# UNITED STATES PATENT AND TRADEMARK OFFICE

10/675,107

<b>Office Action Summary</b>	Application No. 10/675,107	Applicant(s) WACK ET AL.	
	Examiner Anu Ramana	Art Unit 3733

## **DETAILED ACTION**

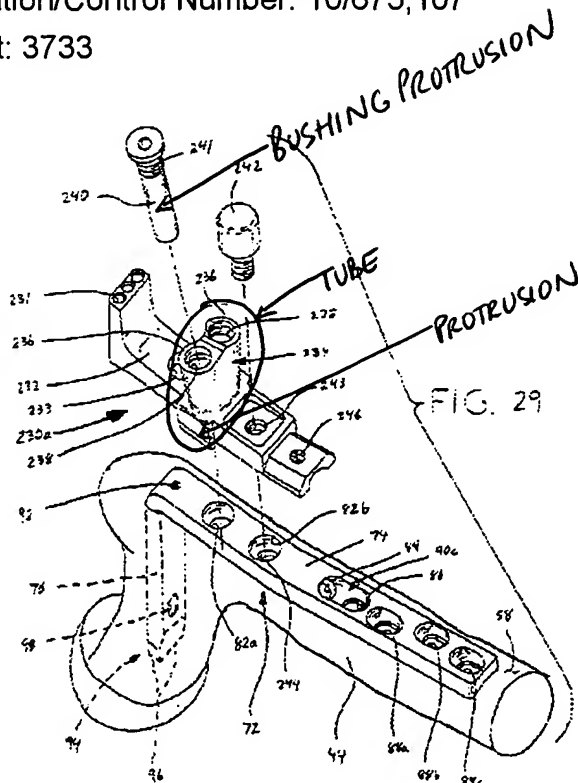
Aikins et al. disclose a guide 230a including: a body attachable to a bone plate; a tube 234 fitted to the body; and drill sleeves or bushings 240 with protrusions wherein the tube includes a protrusion for cooperation with the bone plate and a drill 135 is used to drill holes (Figs. 29-33 and paras [0089] – [0093]). See marked up Fig. 29 from Aikins et al. on the following page.
